# Annual Monitoring Report

Mill Dam Creek Restoration Site  
Yadkin River Basin - 03040101  
Monitoring Year 03  
DEQ Contract 6898  
DMS Project Number 97136  
DMS RFP No. 16-006706 (Date of Issue: October 21, 2015)

Date: February 10, 2023  
To: Matthew Reid, DMS Project Manager  
From: Adam Spiller, Project Manager  
KCI Associates of North Carolina, PA  
Subject: Mill Dam Creek Stream Restoration Site  
MY-03 Monitoring Report Comments  
Yadkin River Basin CU 03040101  
NCDMS Project # 97136  
Contract # 6898

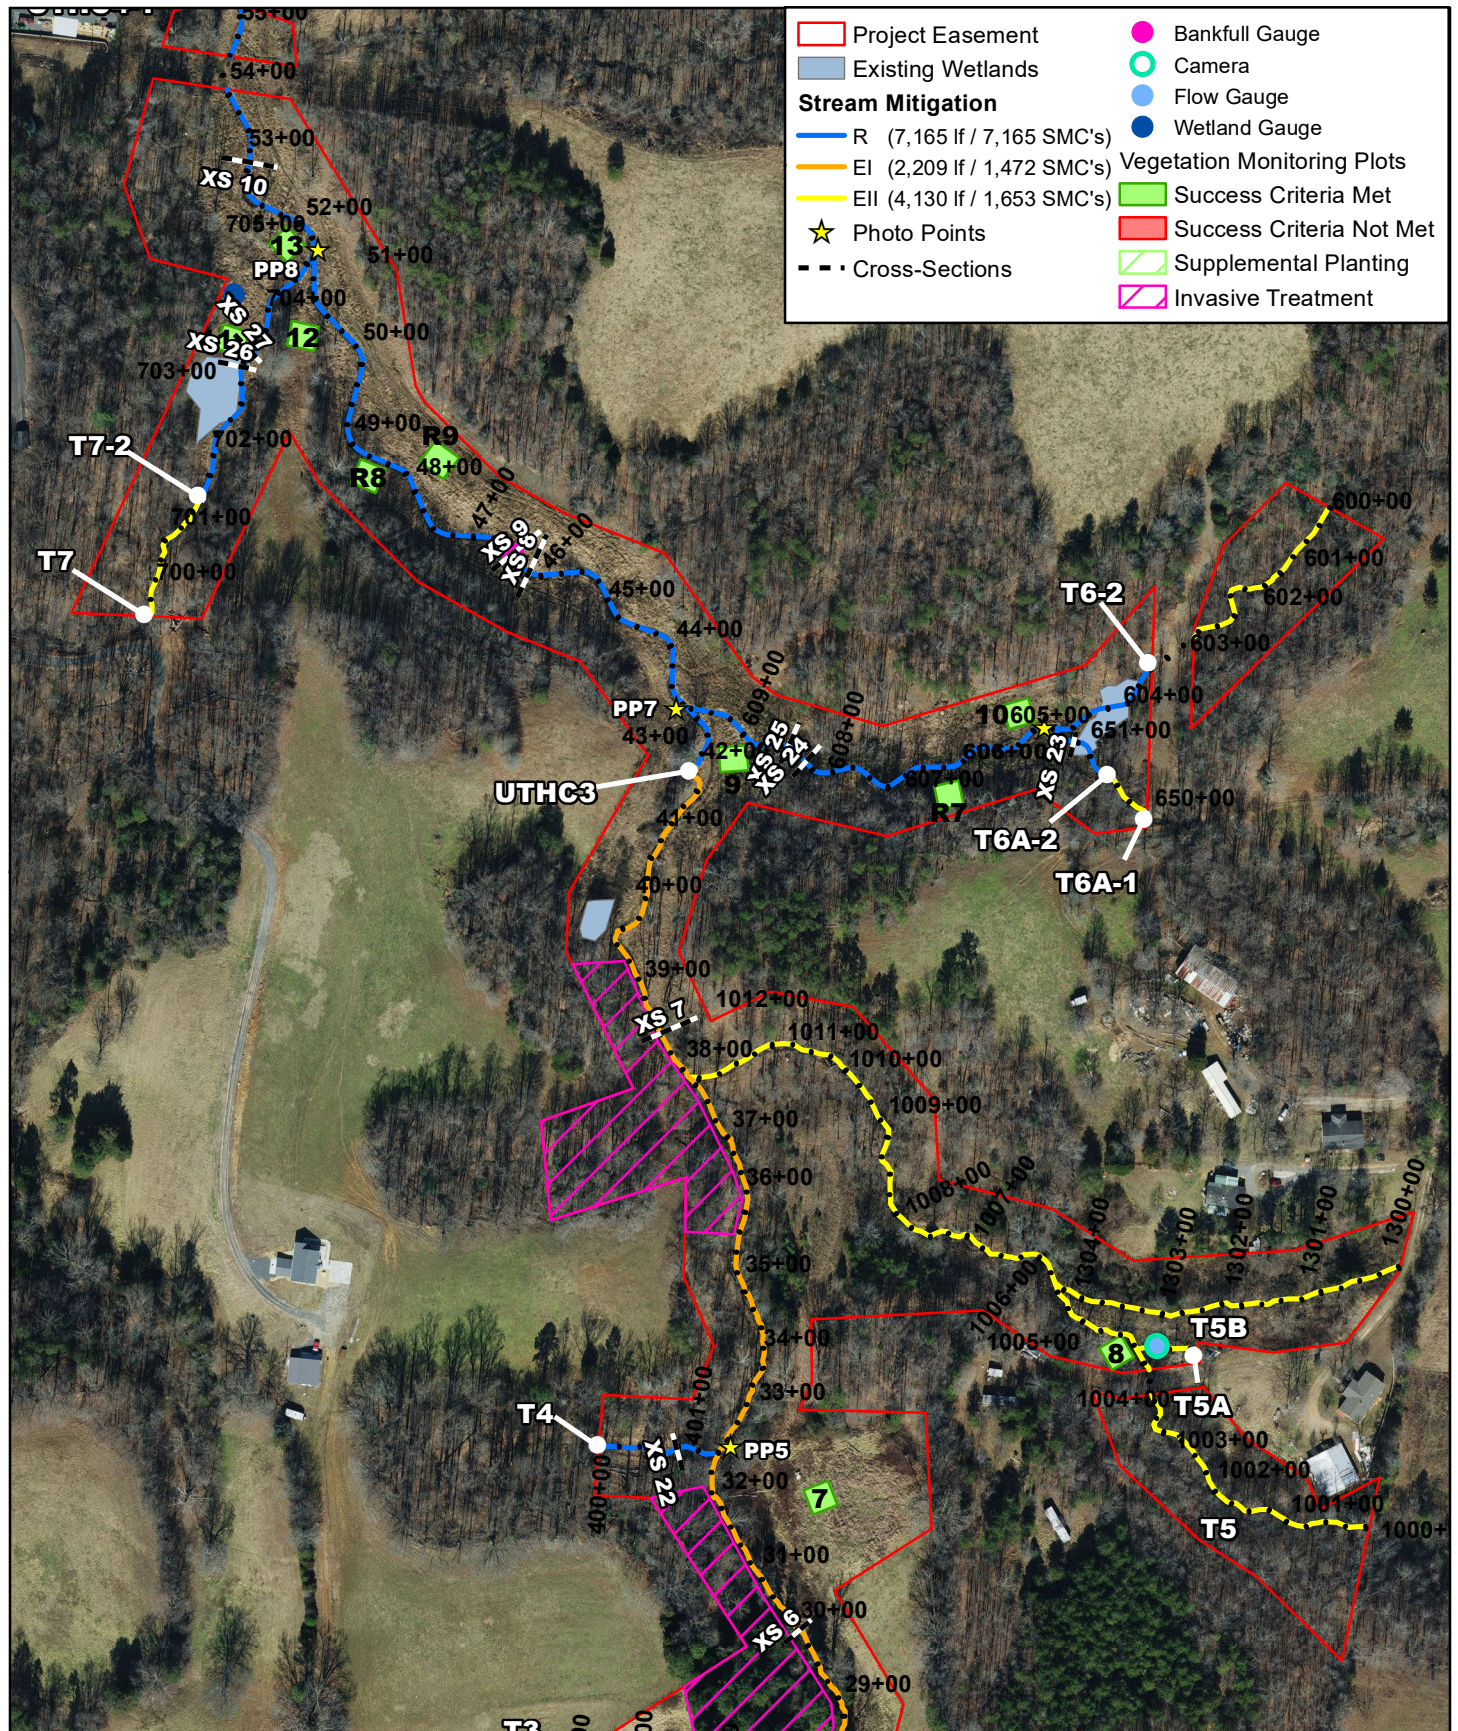
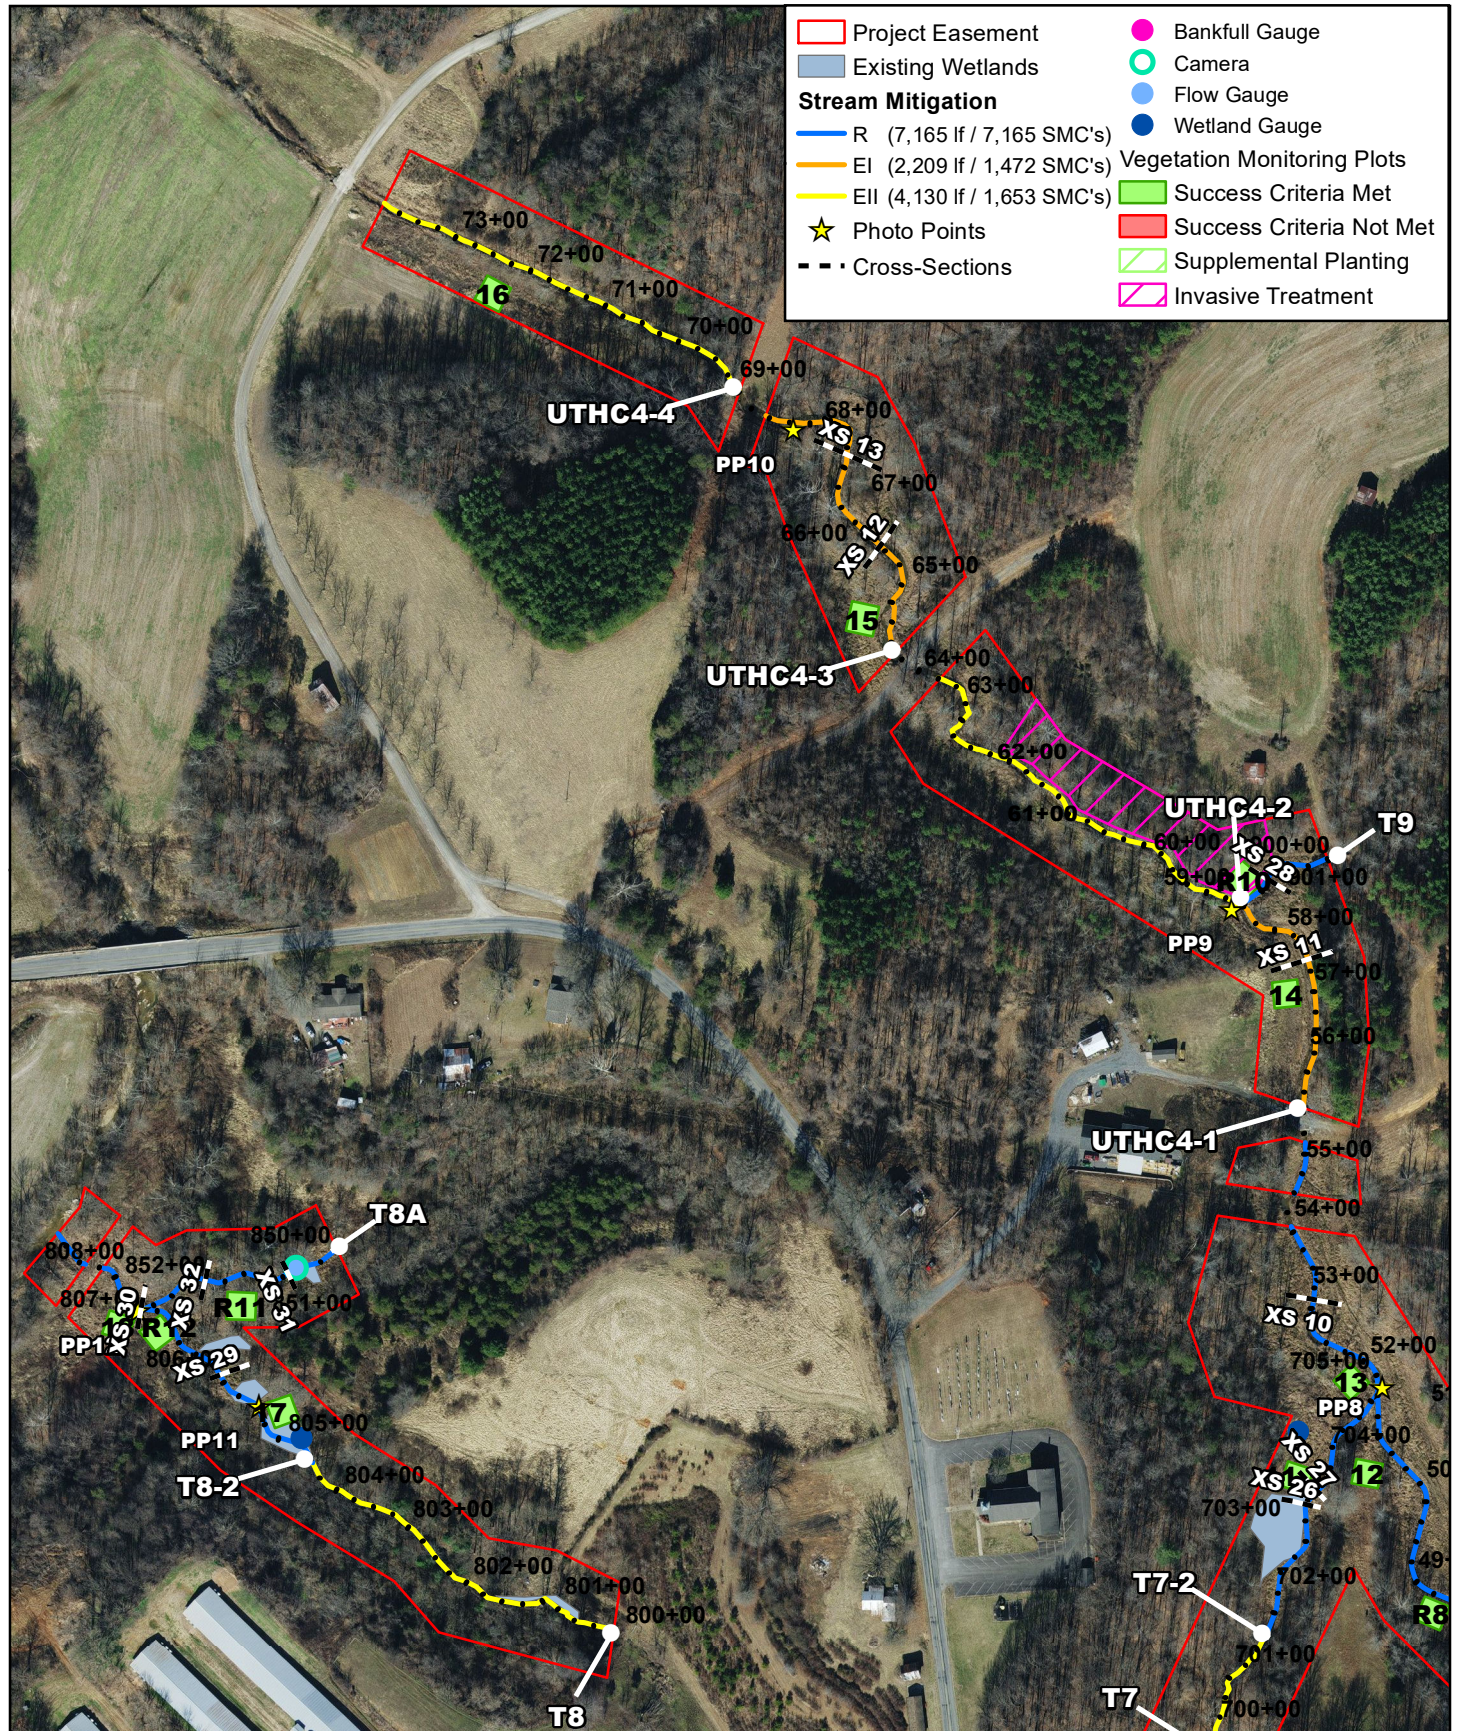
- CCPV: Currently there are several reaches not shown on CCPV sheets. Can sheets 3 and 4 be modified to show all project reaches? Also, the legend conceals reaches on several sheets. Can this also be revised to clearly see the project?  
*KCI Response: The CCPV has been reworked to correct these errors.*

# Mill Dam Creek Restoration Site Hydrograph Wetland Gauge 2, T8

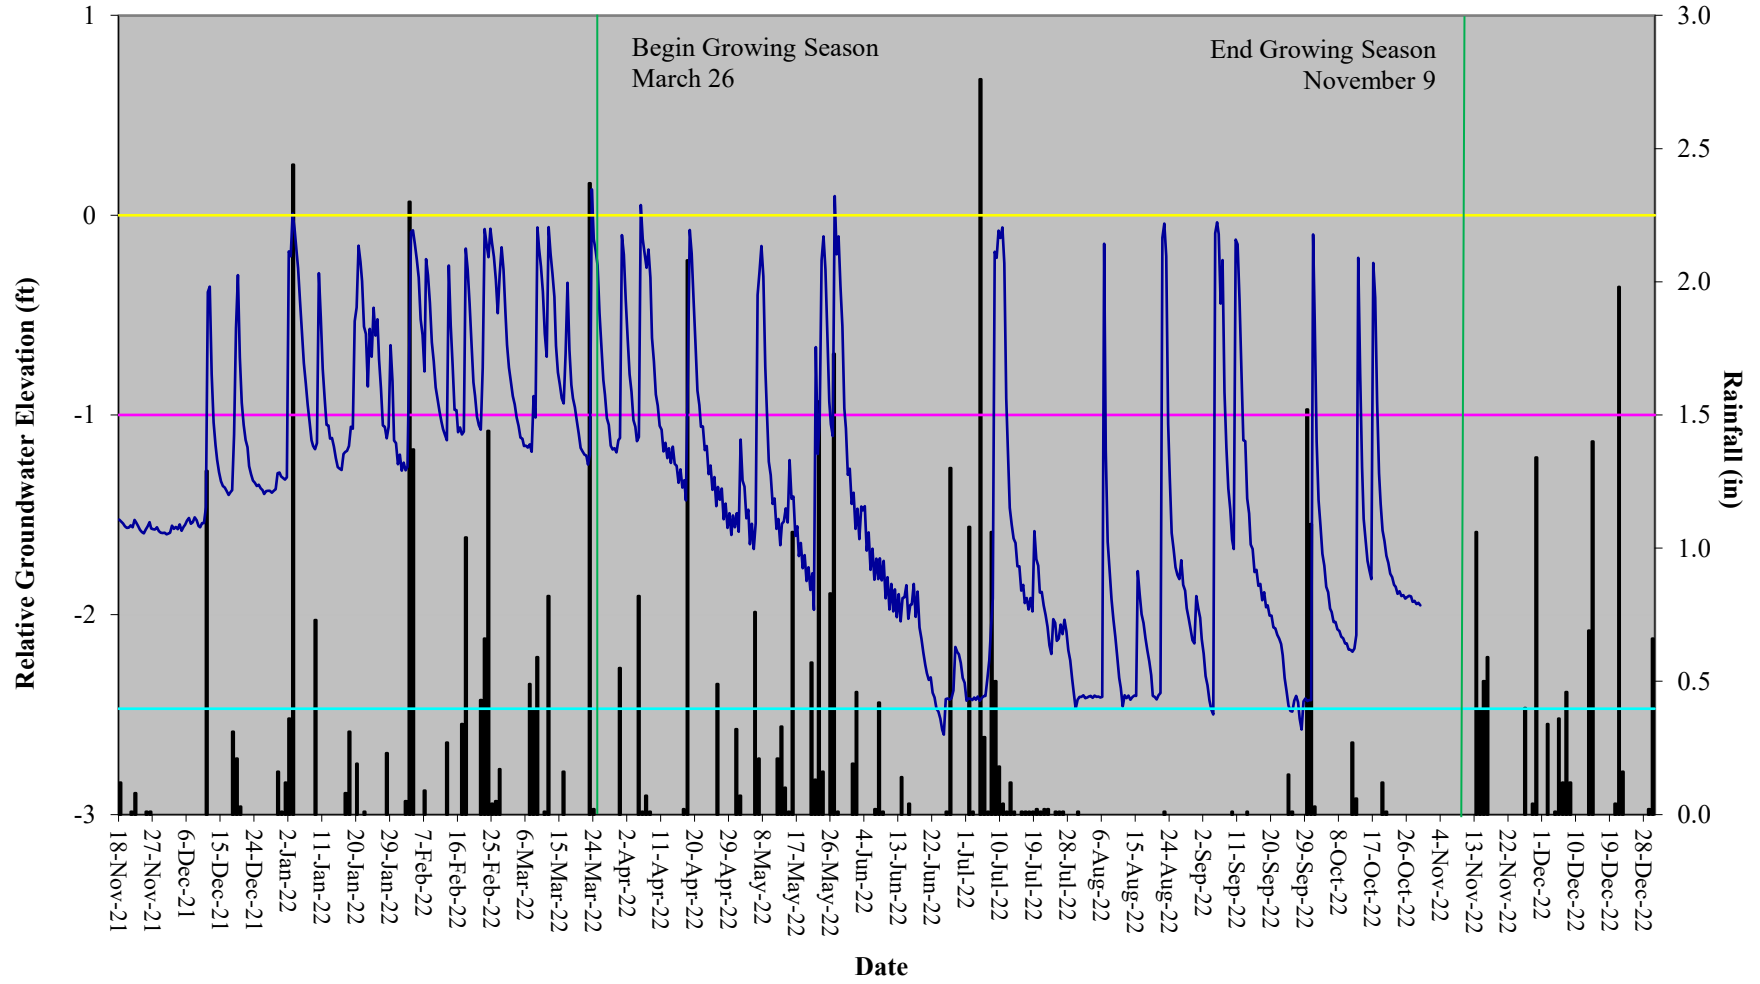
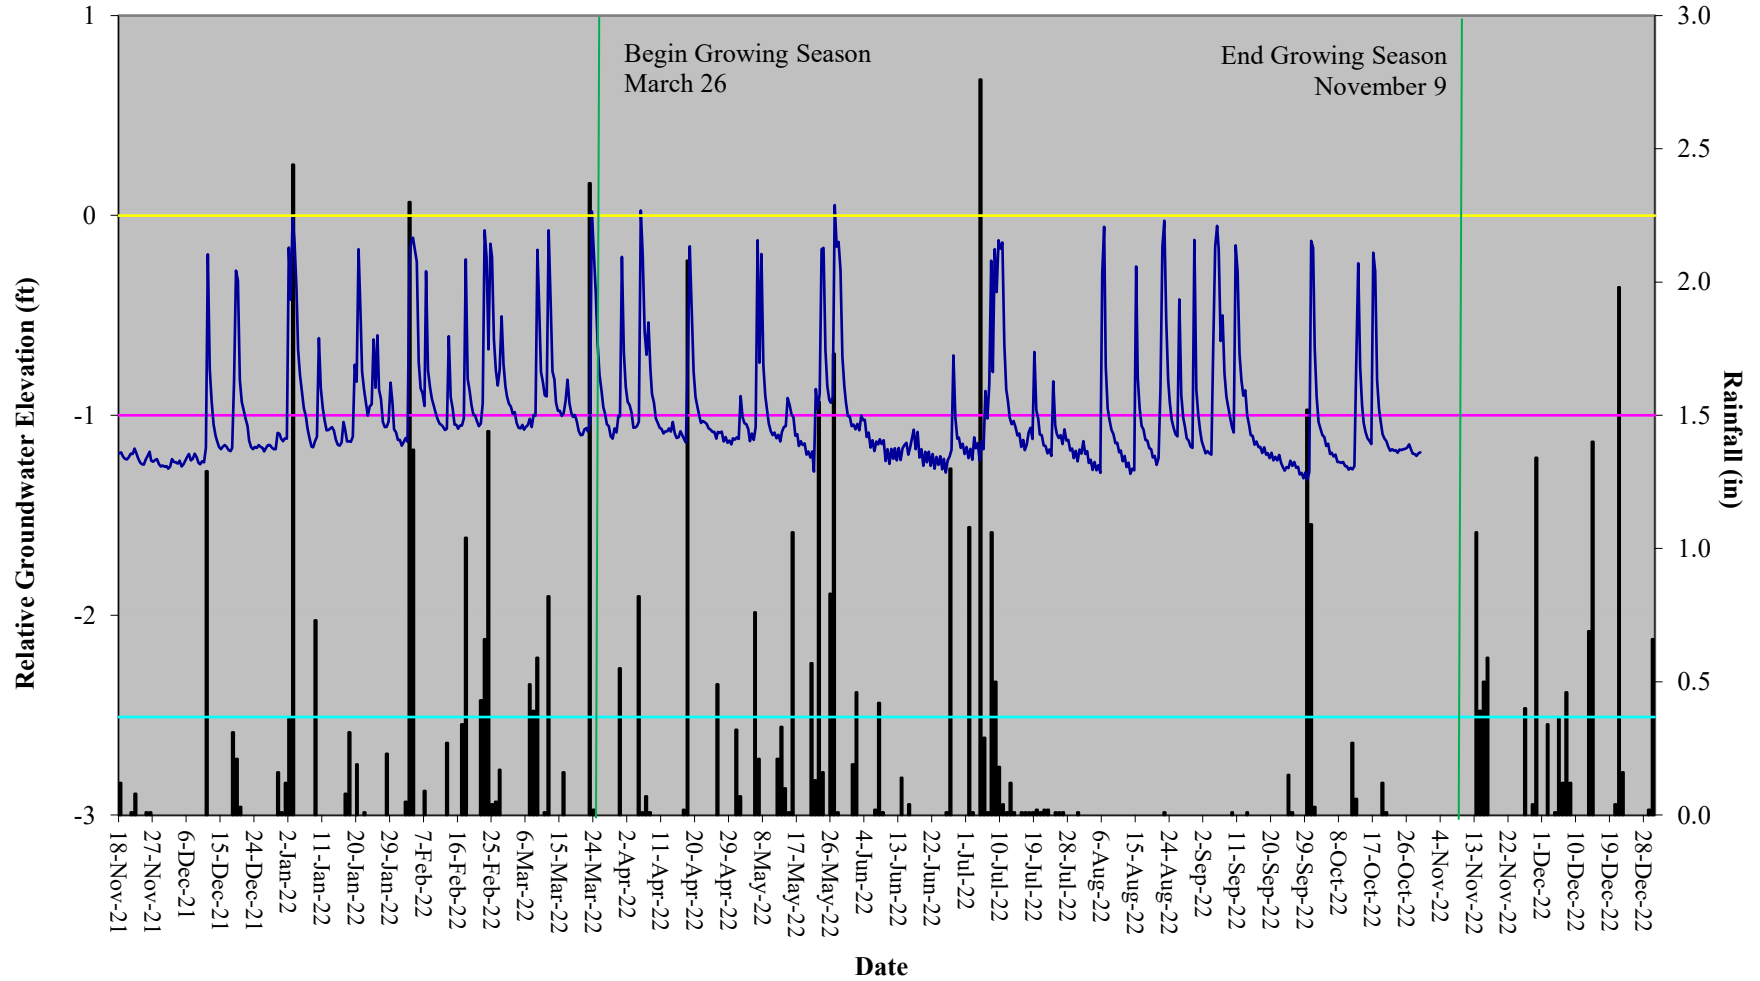
- Hydrographs: Please verify that the yellow line and pink line are labeled correctly for wetland gauge 1 and 2. It appears that the yellow line should be ground surface.  
*KCI Response: The labels on these graphs have been corrected.*
